NOTICE OF ADDENDUM

ADDENDUM NO. 2

CITY OF MADISON
NAKOOSA TRAIL FLEET/FIRE/RADIO SHOP FACILITY

S-131B

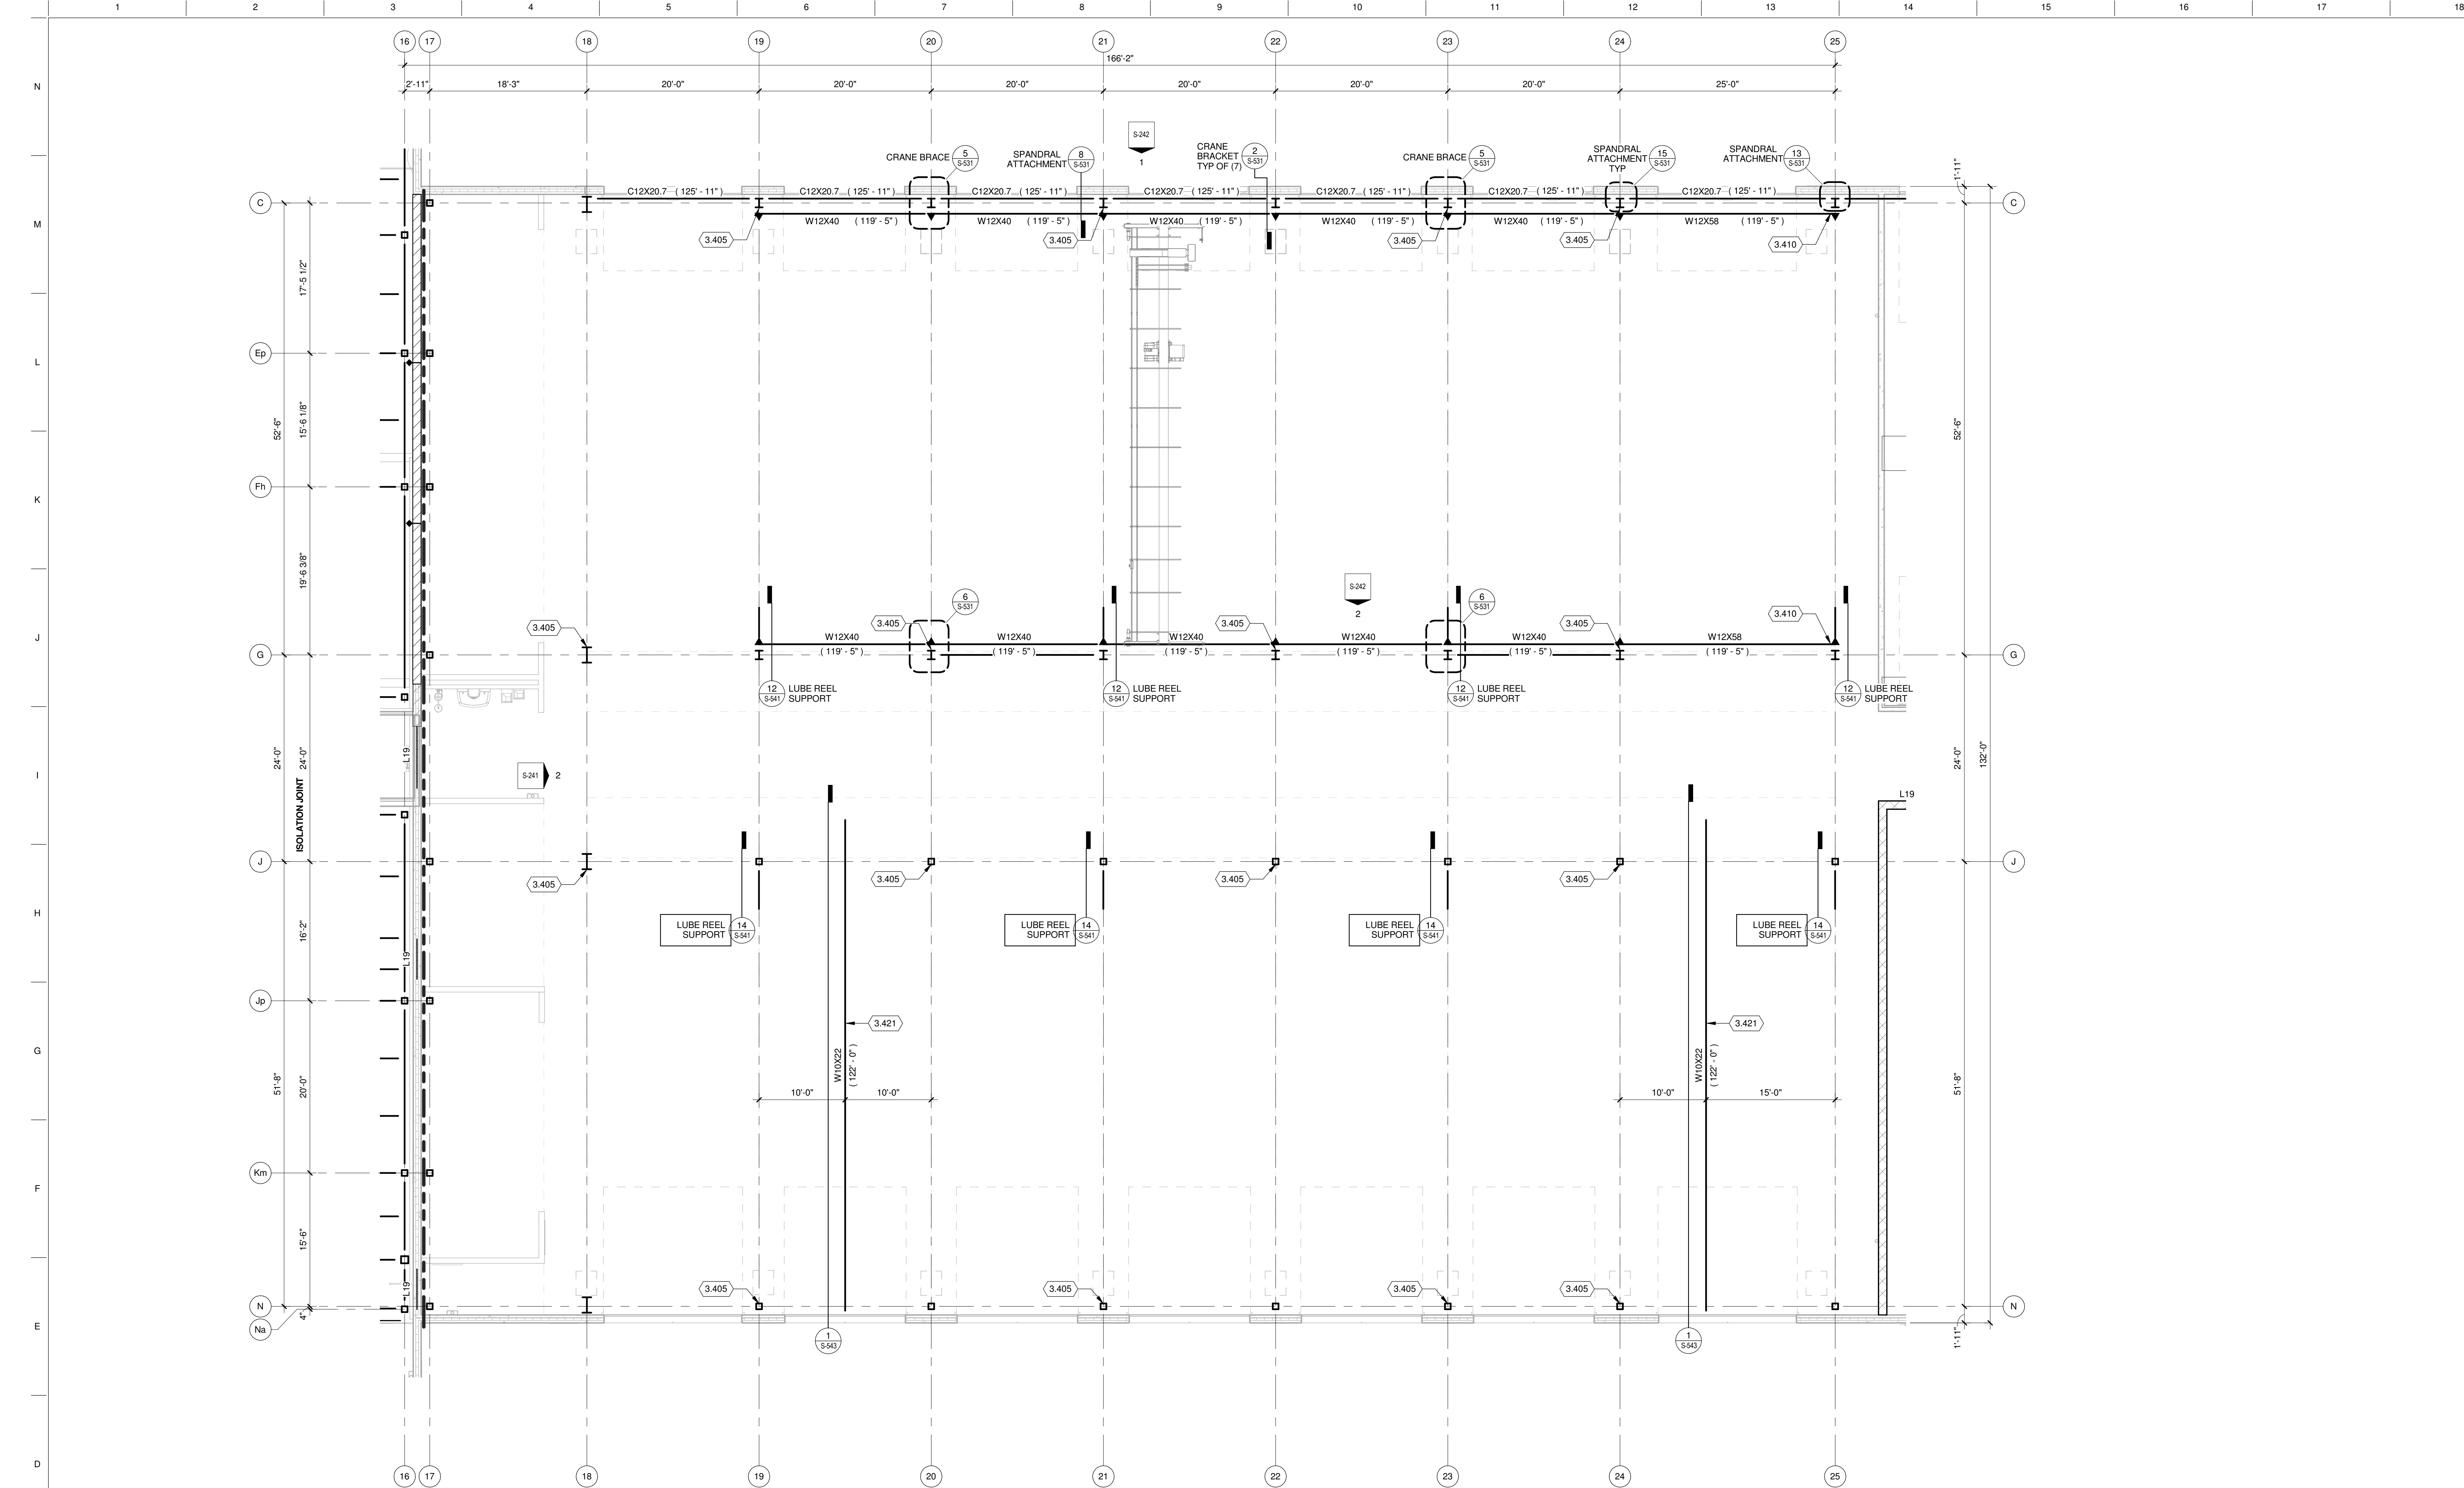
- CCC. **MODIFIED** S-131B LEVEL 1 STRUCTURAL FLOOR PLAN AREA B to:
 - a. Shift Grid R north 1-inch and revise grid dimensions as indicated
 - b. Add Keyed Note 3.306 as indicated

- c. Revise Structural Floor Plan General Note 13 as indicated.
- DDD. **MODIFIED** S-131C LEVEL 1 STRUCTURAL FLOOR PLAN AREA C to revise Structural Floor Plan General Note 13 as indicated.

S-132A

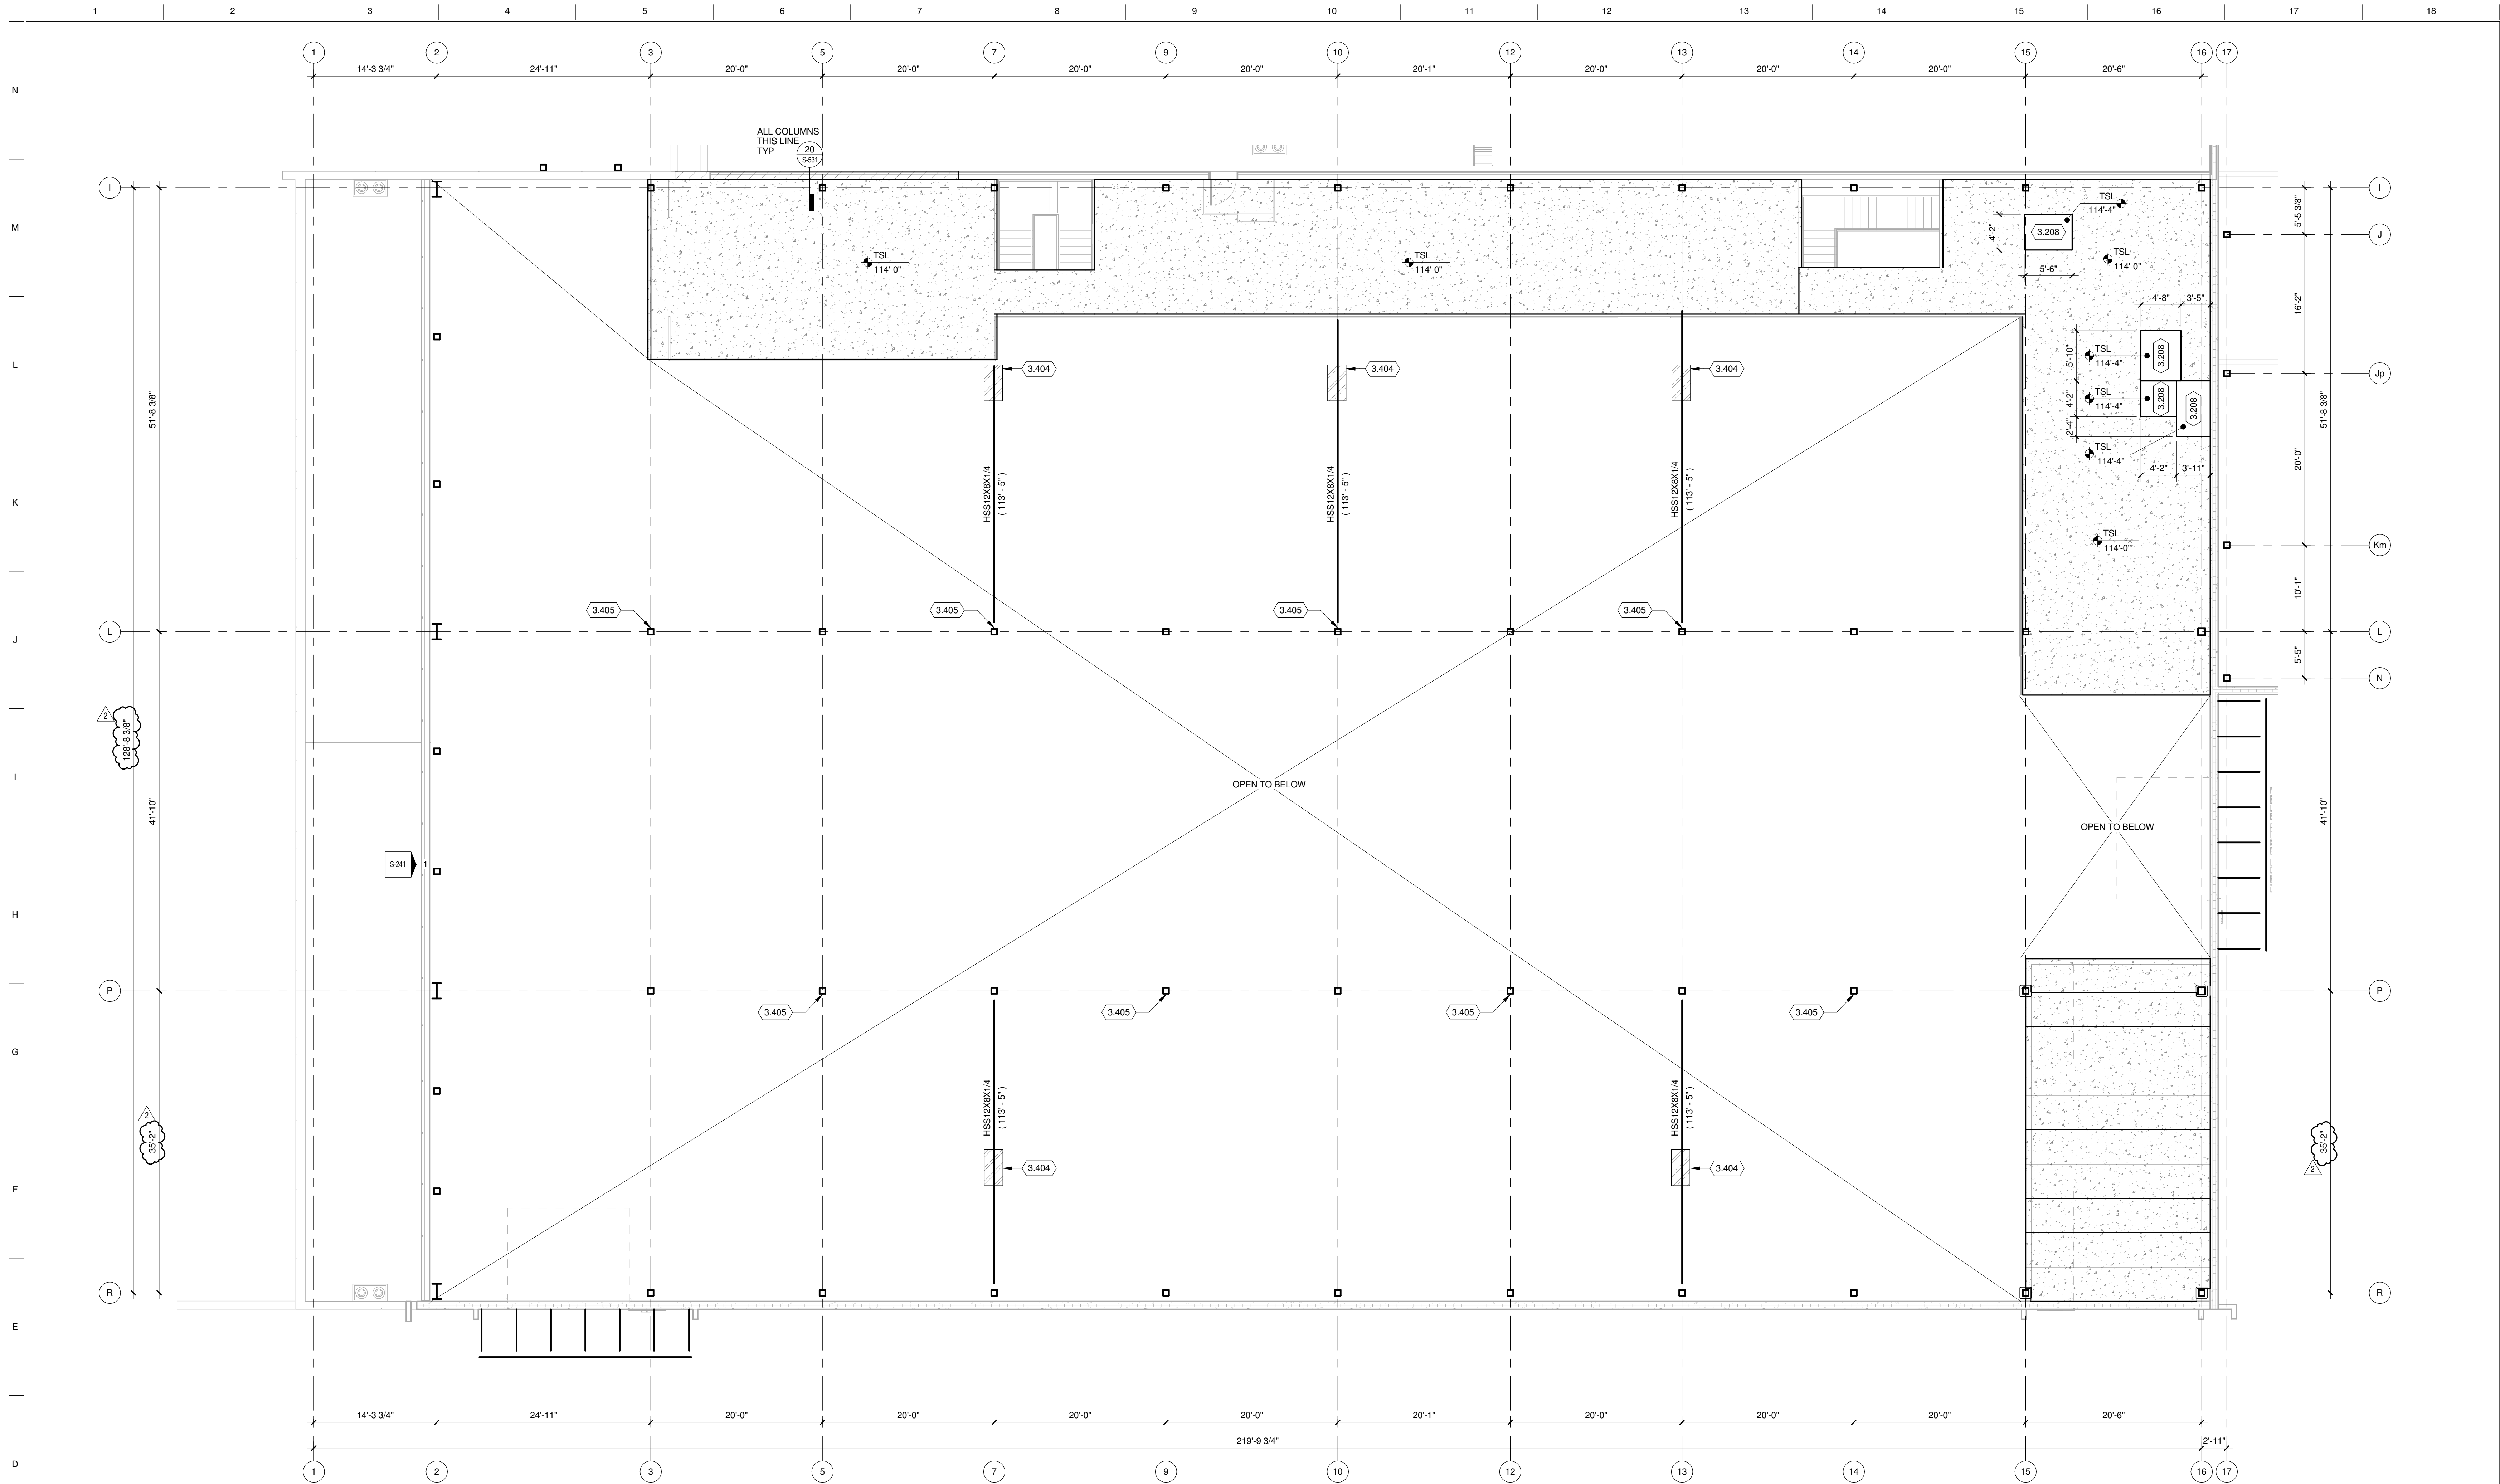
- GGG. **MODIFIED** S-132A MEZZANINE STRUCTURAL FLOOR PLAN AREA A to add masonry control joints as indicated and to revise Structural Floor Plan General Note 13 as indicated.

S-132E

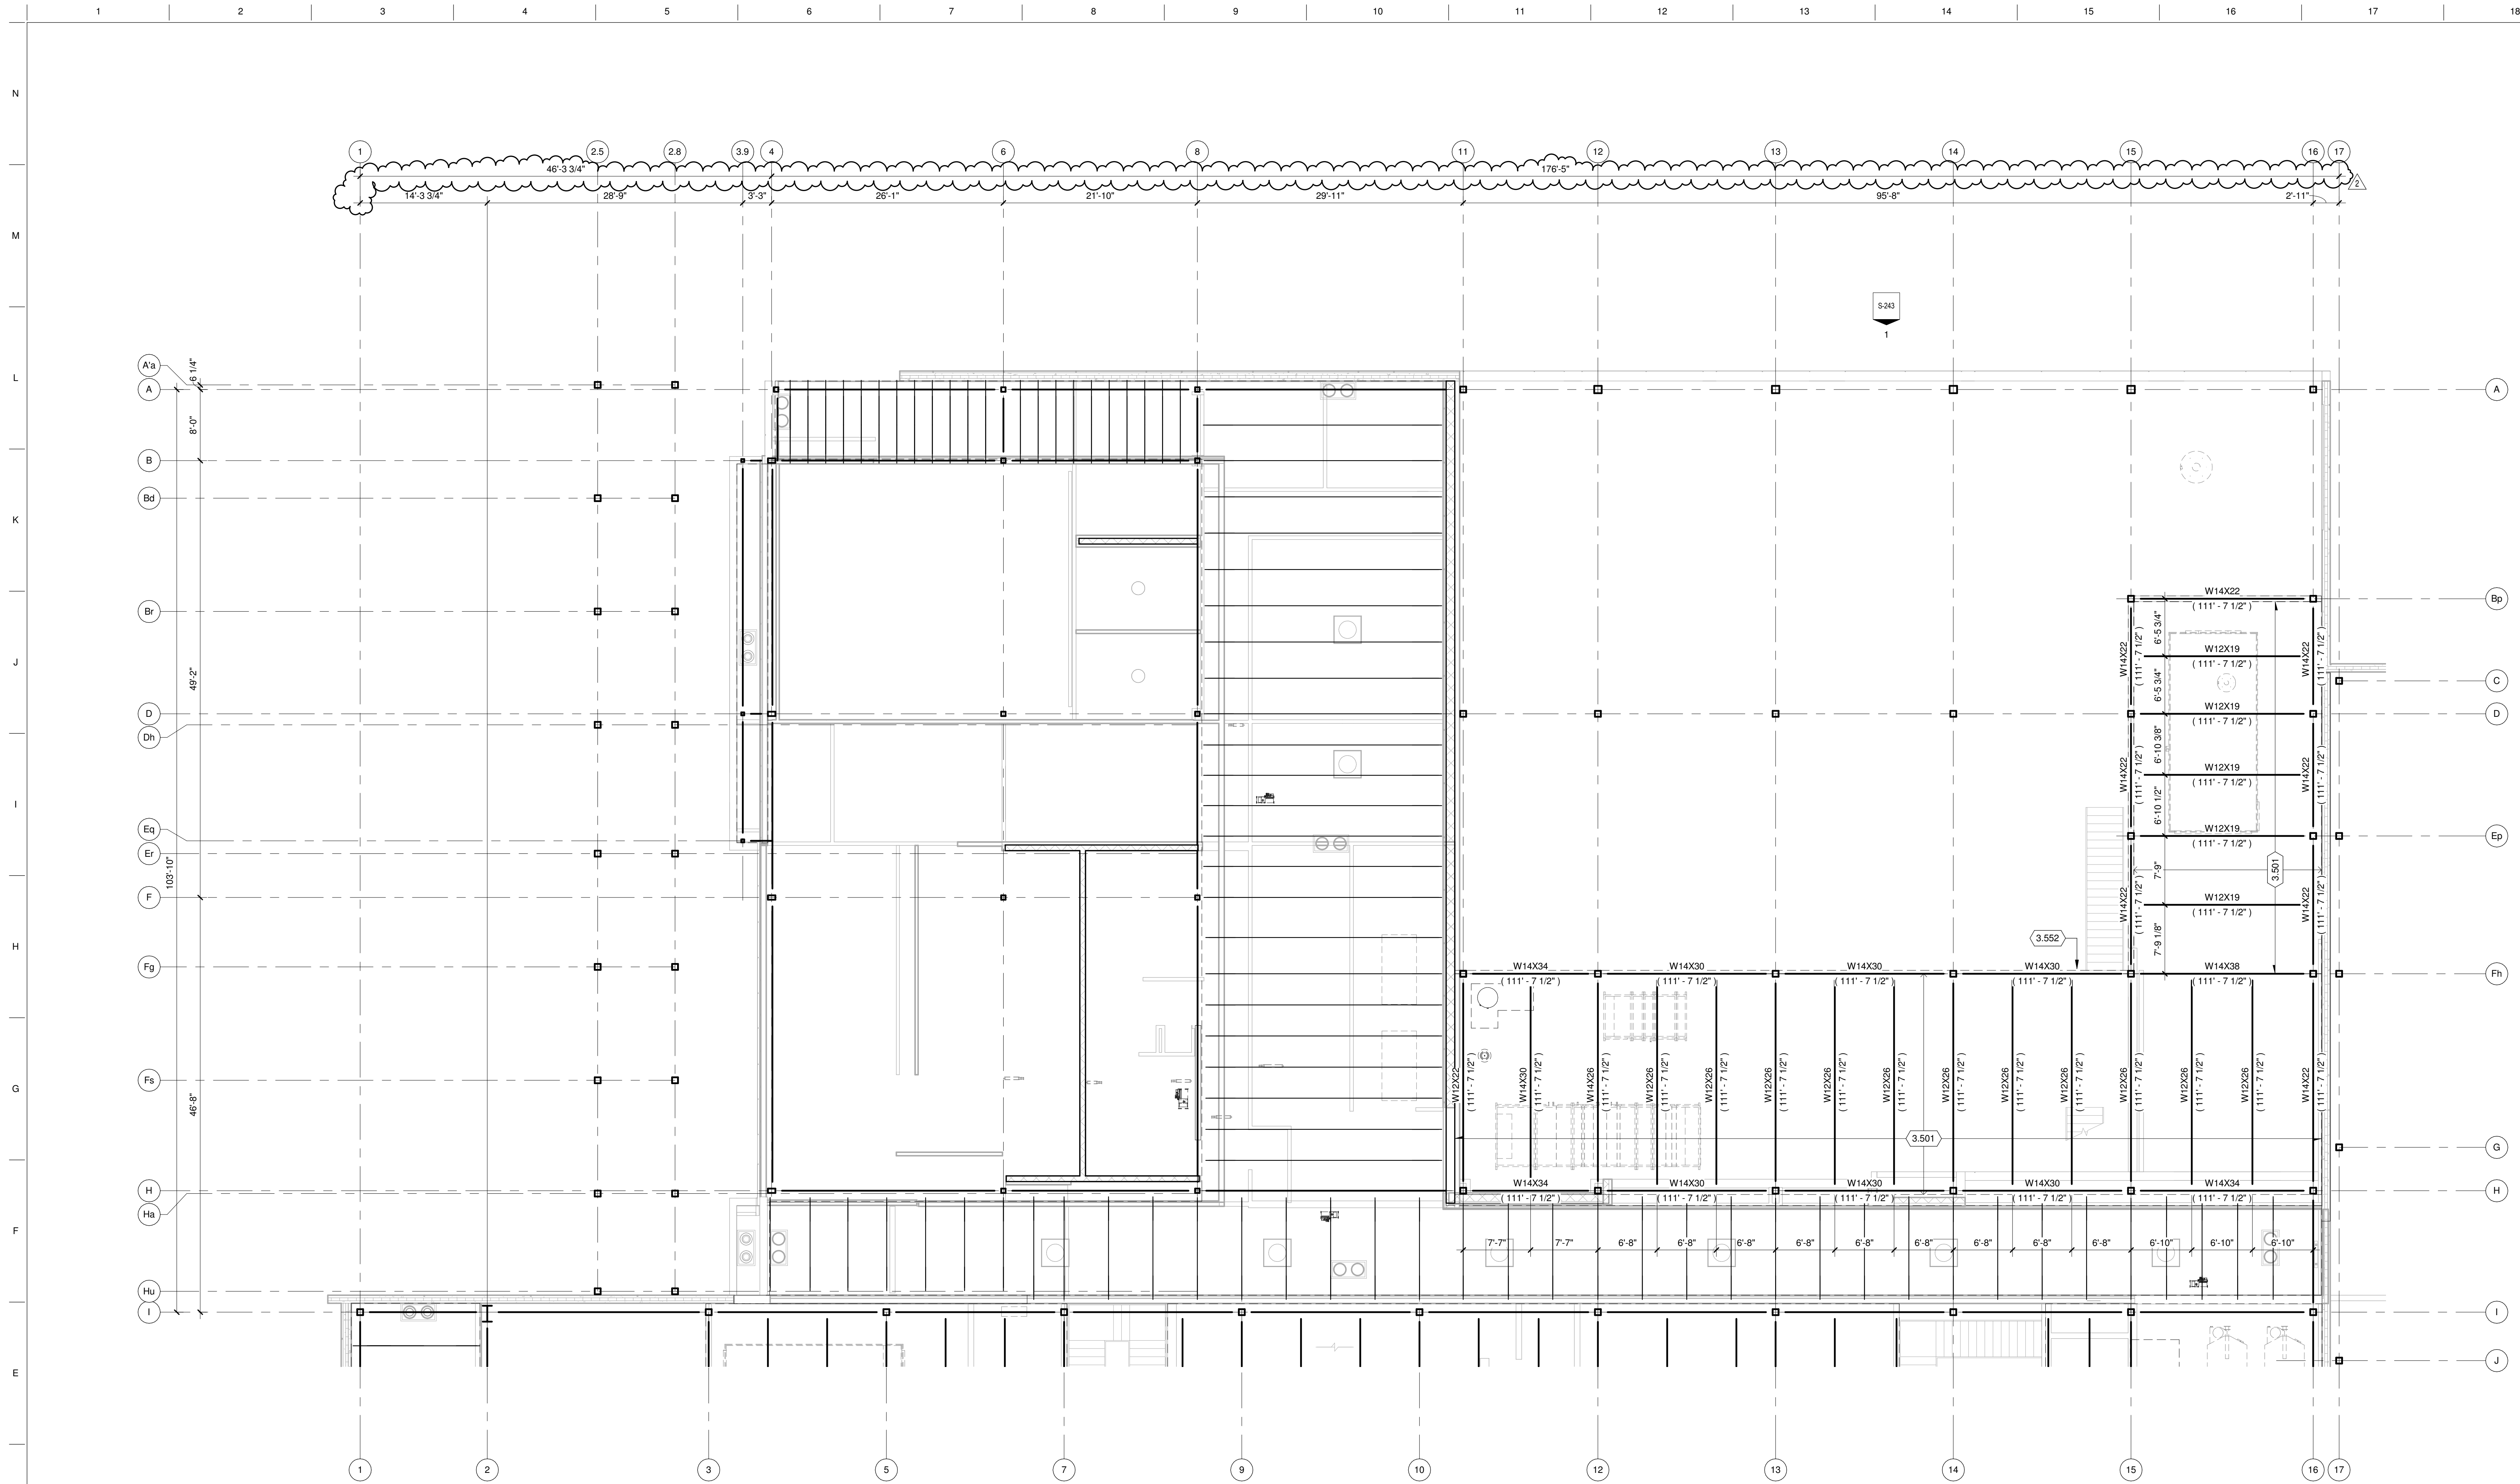
- Revise Structural Floor Plan General Note 13 as indicated.
- JJJ. **MODIFIED** S-132E MEZZANINE STRUCTURAL FLOOR PLAN E to add masonry control joints as indicated and to revise Structural Floor Plan General Note 13 as indicated.
